Staff Report

Report: May 15, 2025

Item: PSPR25-0003 and PSPR25-0005: A public hearing to consider two Site Plan Review Permit applications for two mixed-use multi-family/commercial developments consisting of 47 apartment units and approximately 847 sf of commercial space on .16- acres located at 413 Church St. and 41 apartment units and approximately 1,900 sf of commercial space on a .16-acre site located at 417 Church St.

Figure 2 Site Plan showing the combined development, Buildings 1 & 2 main floor

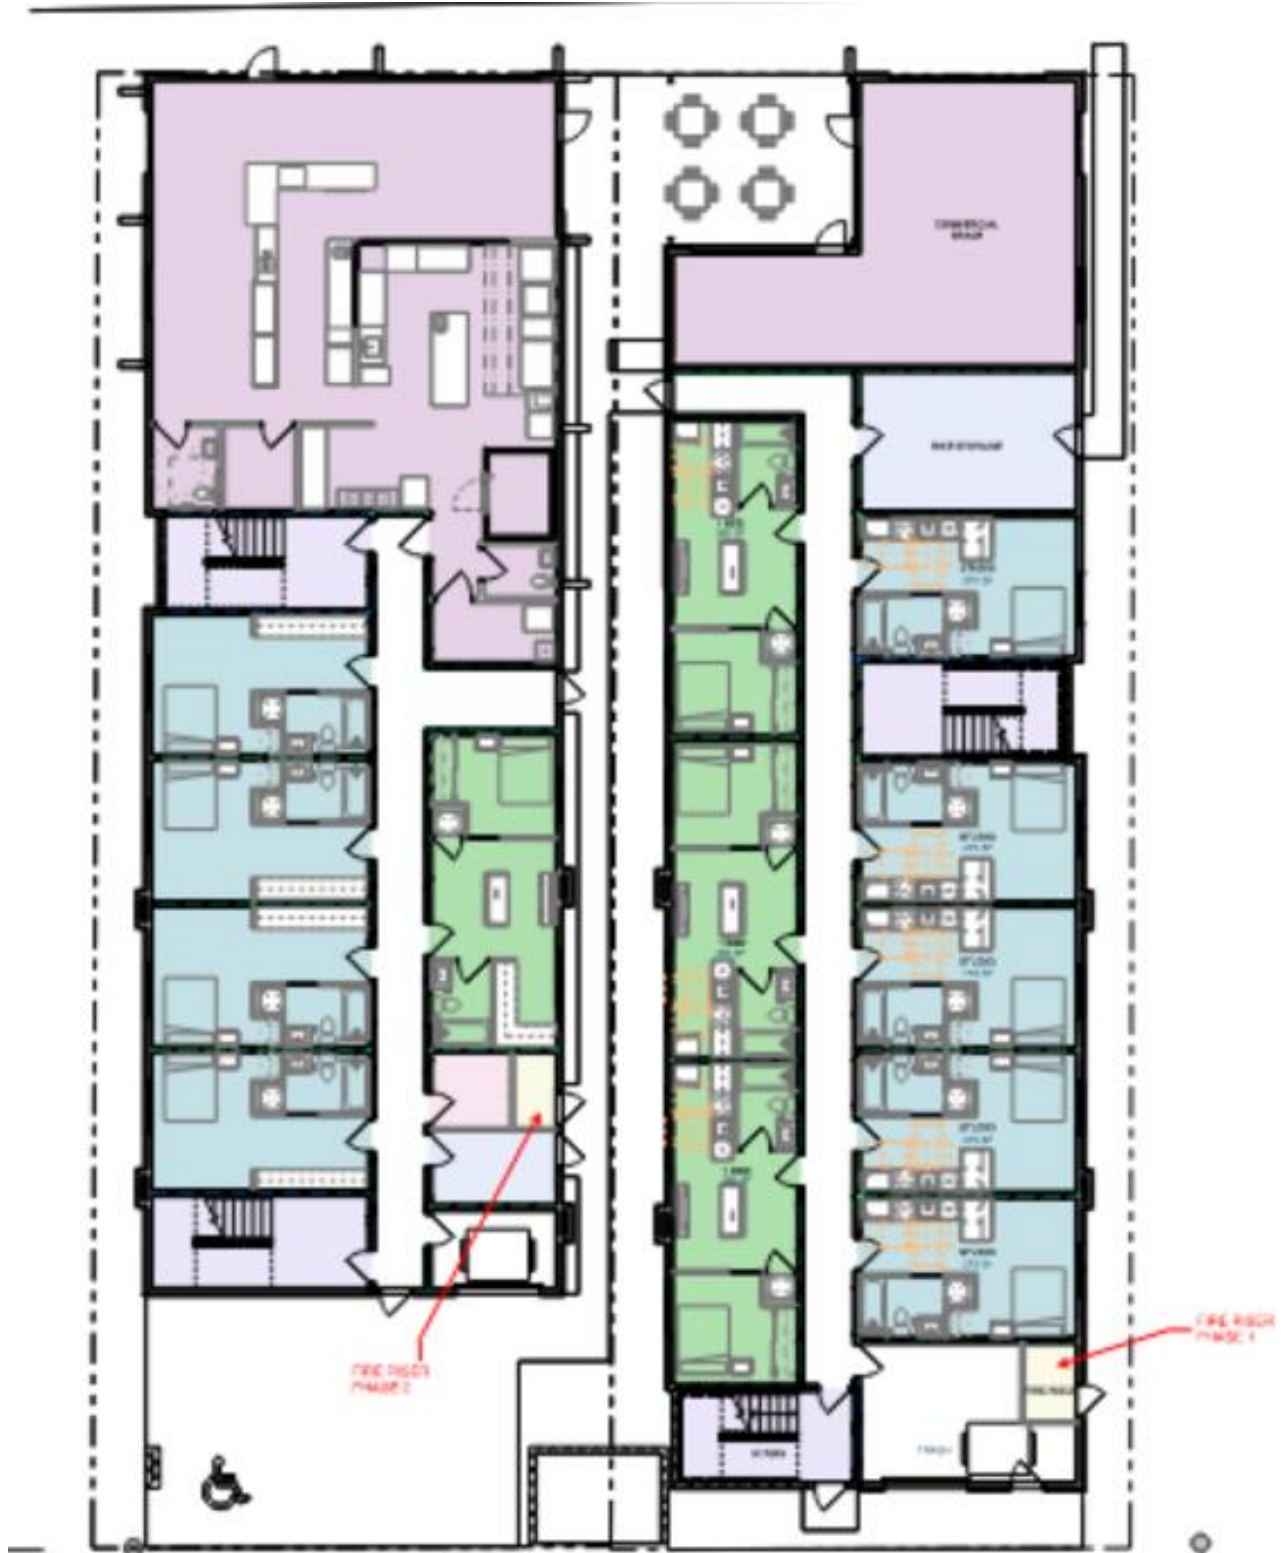
2. Bike parking recommendations: add bike parking to building 1 similar to what is visible in building 2 site plans. Optimal bike parking would be inside the building, first floor, lockable to building, separate from trash space, and easily accessible with an outside entry and inside entry. Recommend offering 1 bike space in these parking areas per living unit (many people without cars have multiple bikes); and, furthermore, ensure that 1 in 5 spaces are extra wide to accommodate e-bikes. Ensure availability of adequate power outlets for e-bike charging within dedicated bike storage spaces. Encourage space for lockers or storage in bike parking areas, and wide enough doorway entry/access for ancillaries like panniers, baskets, and bike trailers.

Compliance: Both Buildings 1 and 2 include dedicated, lockable bike storage accessible from both inside and outside the units.

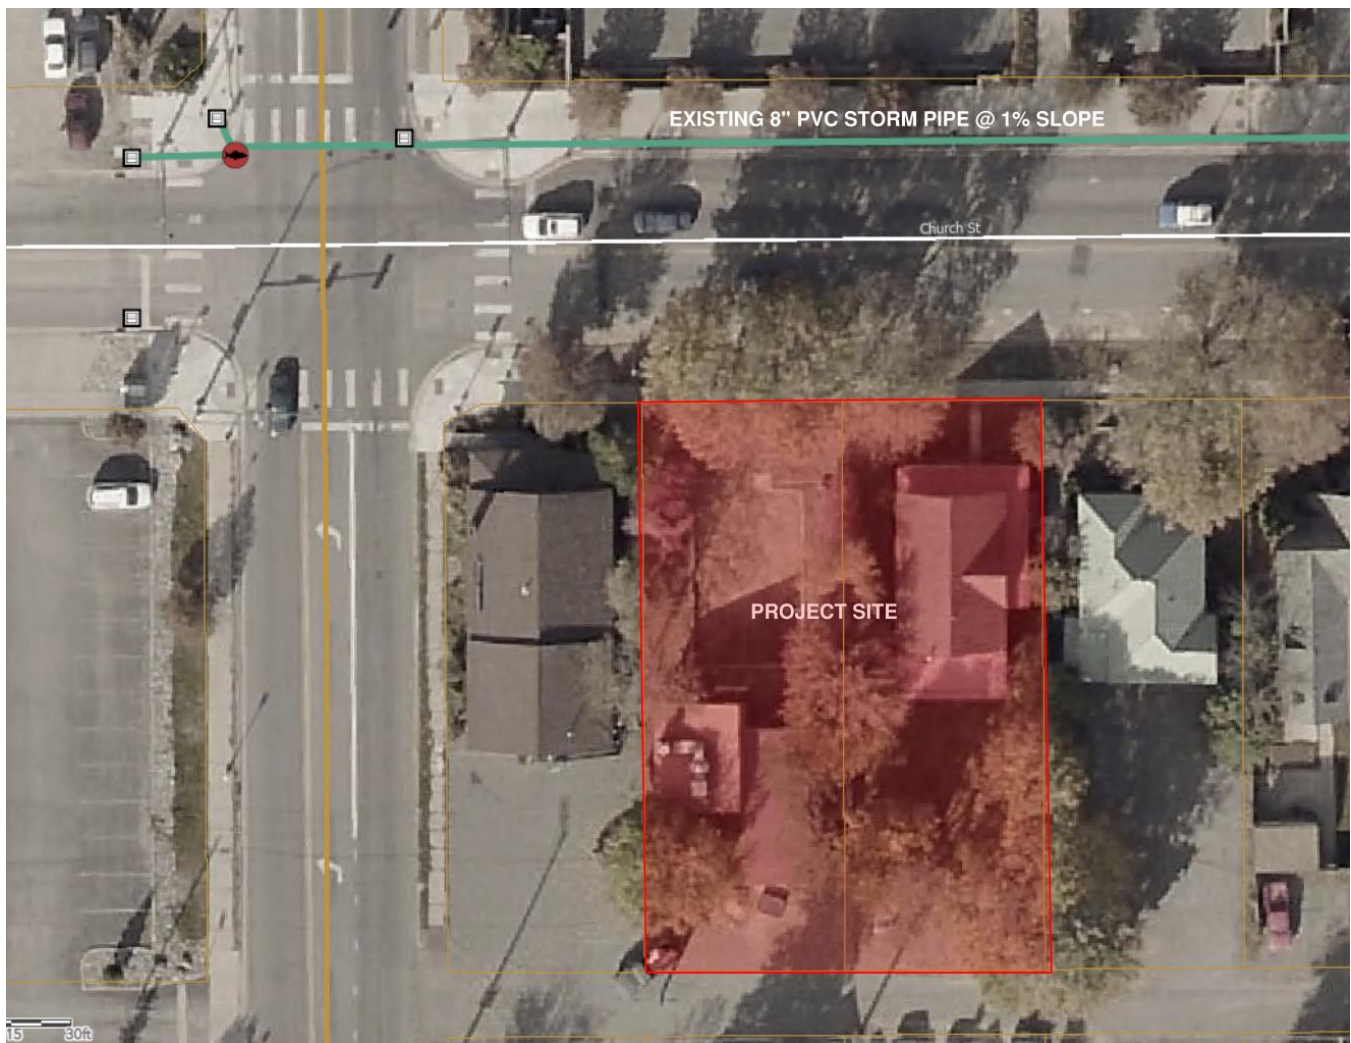
Staff Analysis and Finding: The submitted SWMP demonstrates that there will be no increase in the peak rate of runoff from the site post-construction, compared to the site pre-construction. The existing 8" PVC stormwater pipe in Church Street, which the project stormwater system will discharge to after treatment and detention, does not have any identified deficiencies. The existing stormwater pipe in Church Street is at the upstream end of the network. See image of the existing city stormwater system below.
